The present amendment responds to the Official Action dated October 13, 2004. A petition for a one month extension of time to respond and authorization to charge Deposit Account No. 50-1058 the large entity extension fee of \$120 accompany this amendment. The Official Action objected to informalities in claims 3, 5, 16, 25, 27, and 37-41. The Official Action rejected claims 1, 2-5, 23-27, and 36 under 35 U.S.C. §103(a) based on Ahmed et al. U.S. Patent No. 6,519,773 (Ahmed) in view of Freeman et al. U.S. Patent No. 5,724,091 (Freeman) and further in view of Quigley et al. U.S. Patent No. 6,650,624 (Quigley). These grounds of rejection are addressed below. Claims 6-22 and 28-35 were objected to as being dependent upon a rejected claim base but were indicated to be allowable if rewritten in independent form. Claims 37-41 were indicated to be allowable if the informality claim objection number 3 is overcome. Claims 1-23, 25, 27, 29, 33, and 35-40 have been amended to be more clear and distinct, claims 40 and 41 were amended to renumbered the claims to 39 and 40, respectively, and claim 28 has been canceled. Claim 28 has been rewritten in independent form as newly added claim 41. Claim

FIGURE 1

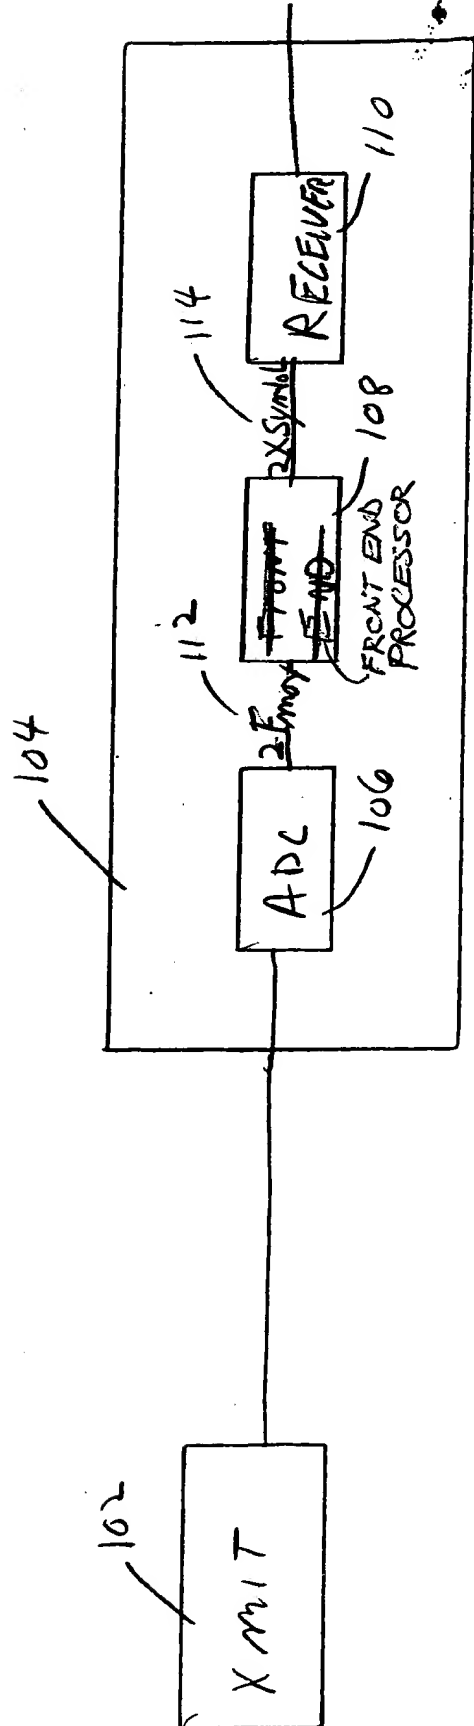
In Fig. 1, the title of element 108 has been changed from "Front End" to "Front End Processor". Support for this change can be found at page 7, lines 19, 20, and 25 where the front end processor 108 is discussed.

FIGURE 2D

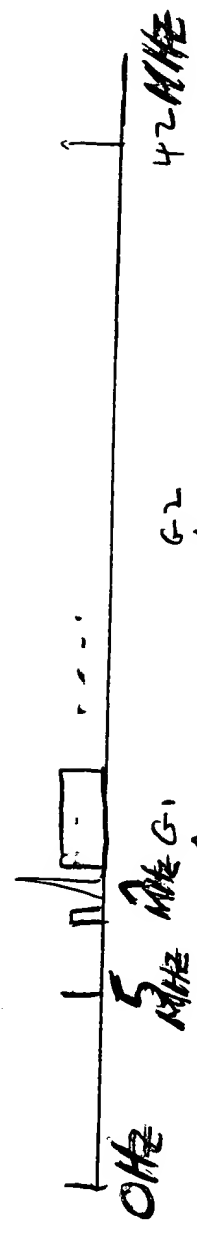
In Fig. 2D, frequency reference points are updated to include the 0 Hz reference point and adding MHz units to the 5 MHz, 7 MHz, and the 42 MHz reference points to be consistent with Fig. 2C, for example. The 7 MHz reference point is the point of interference noted in the specification discussion of Fig. 2D at page 8, lines 17-19.

FIGURE 3

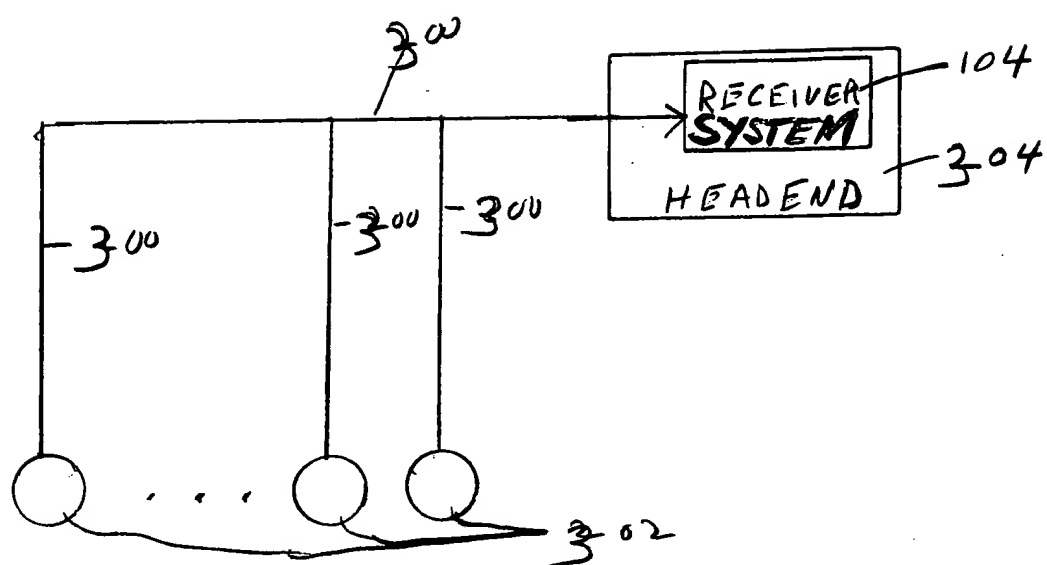
In Fig. 3, the title of element 104 has been changed from "Receiver" to "Receiver System". Support for this change can be found at page 7, lines 15-19 where the receiver system 104 of Fig. 1 is discussed.

FIGURE 6

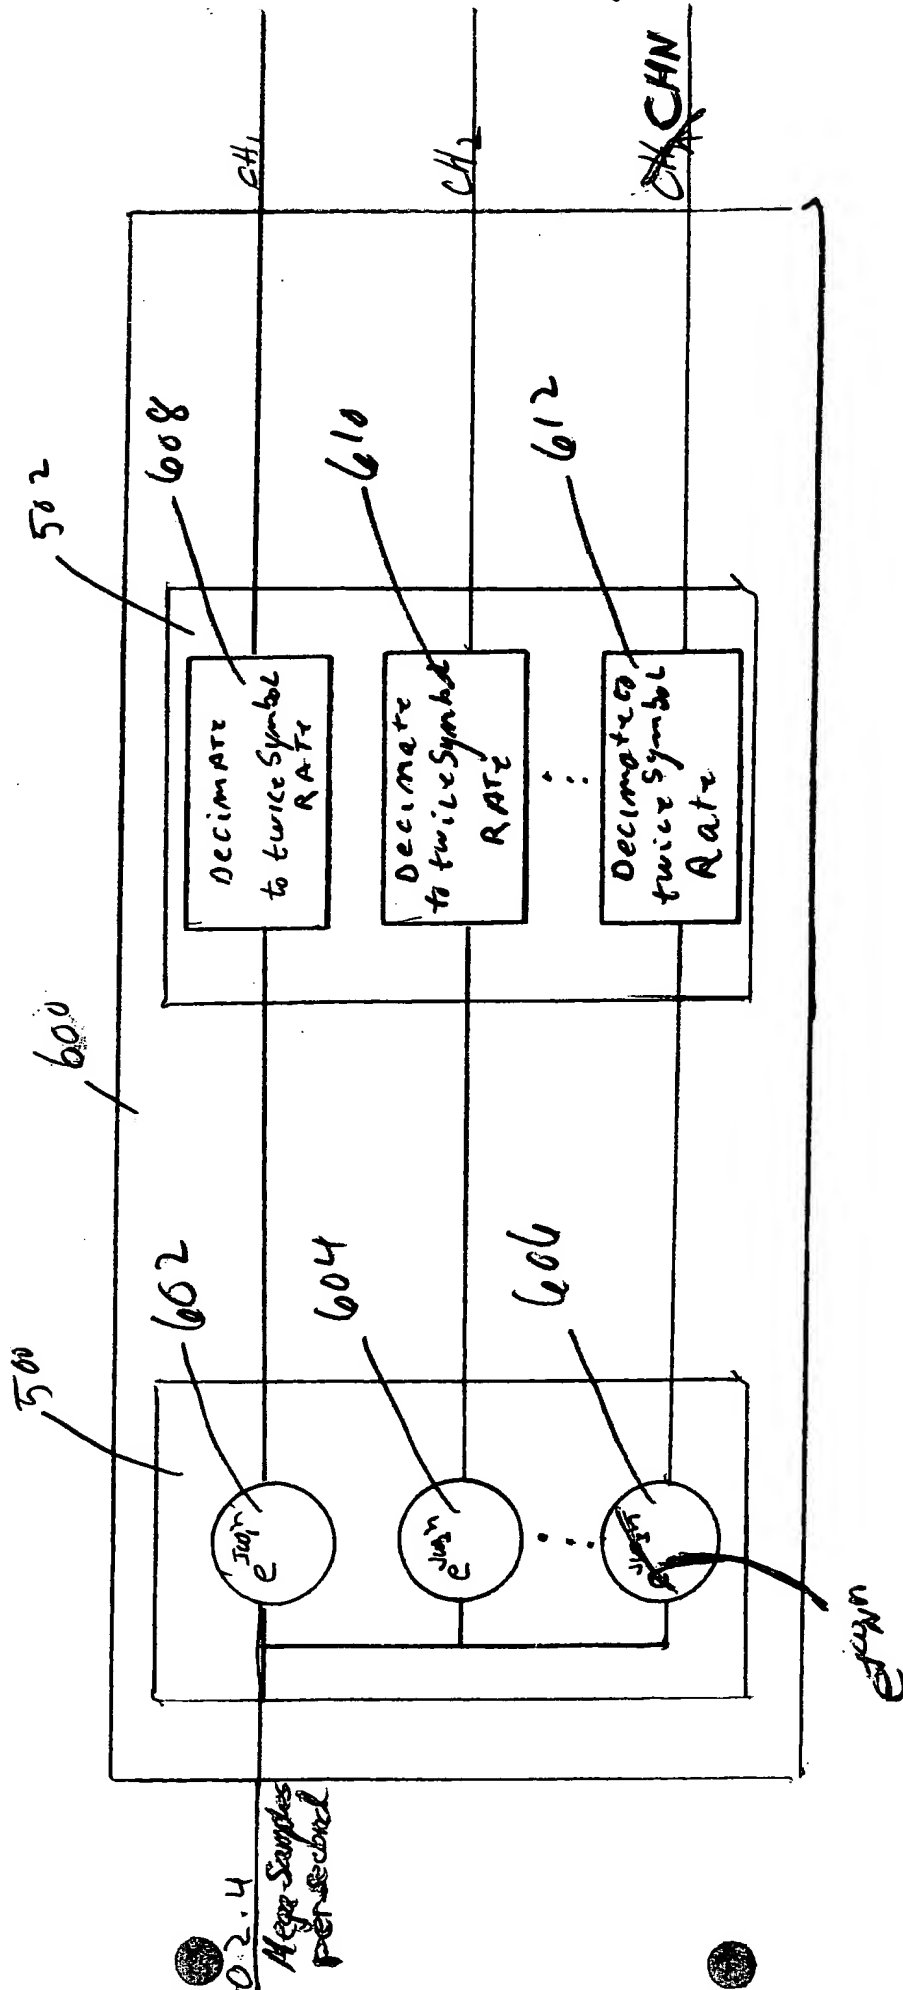
In Fig. 6, the input line labeled "102.4" has been changed to "102.4 mega samples per second" to correspond to the specification at page 11, lines 13-16. The subscript on the down-converter 606 is changed to N for the Nth channel represented in Fig. 6 and the output of decimator 612 is changed to CHN for the Nth channel. Support for these changes can be found at page 12, in lines 8-11 where it is indicated there are N channels within the upstream band and down-converters 602, 604, and 606 are dedicated to one of the N channels. Down converter 606

is the last down-converter in the series and consequently corresponds to CHN as also indicated by the CHN output of the decimator 612 connected to down-converter 606.

FIGURE 12

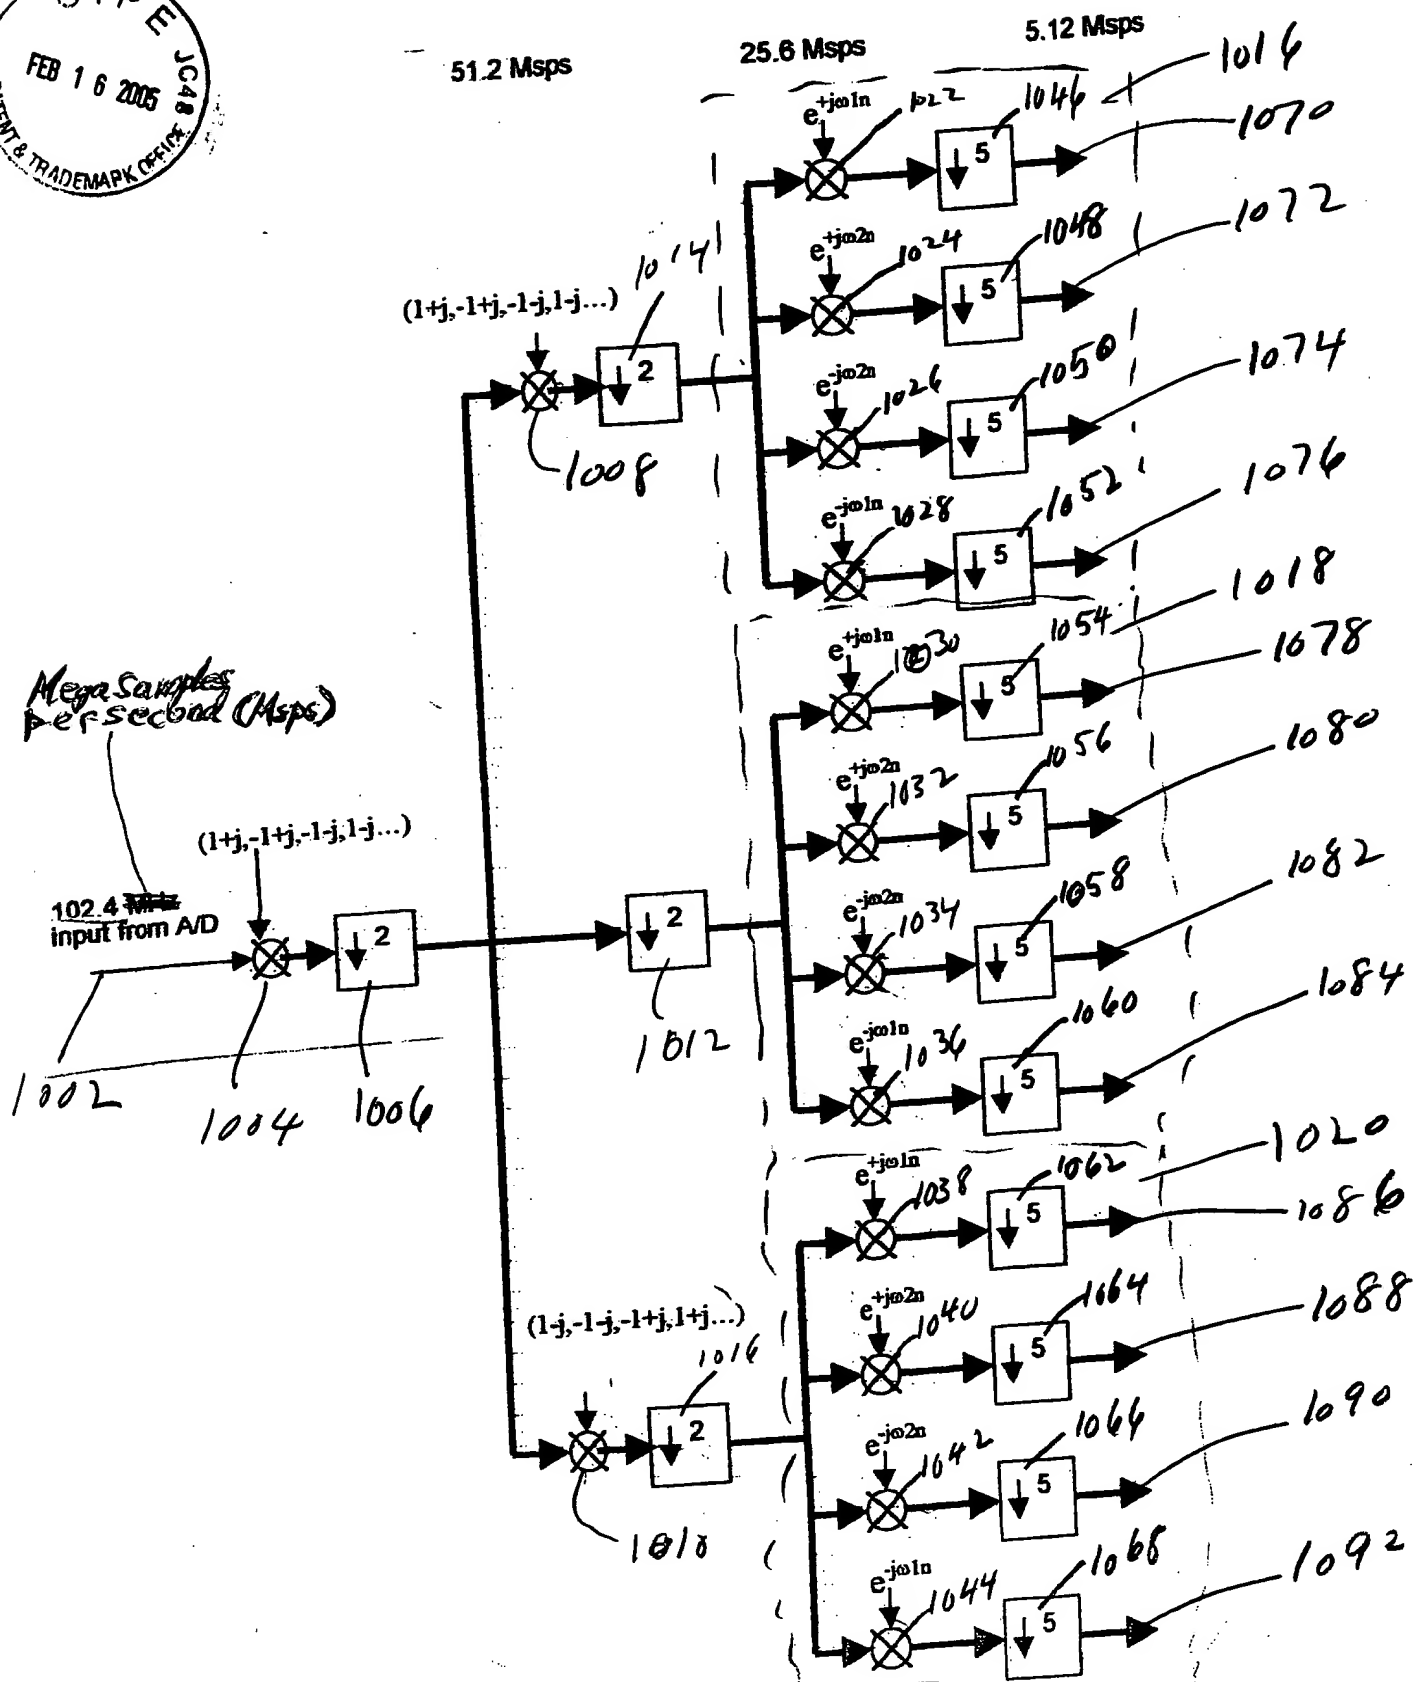
In Fig. 12, the I_n , Q_n , and $Data_n$ labels associated with data memory 1204 have been changed to correct the channel reference number for channel N, changing I_n , Q_n , and $Data_n$ to I_N , Q_N , and $Data_N$. These changes have been made to be consistent with the naming convention for channel N used in the specification and figures, such as Figs 5, 8, and 13, for example.
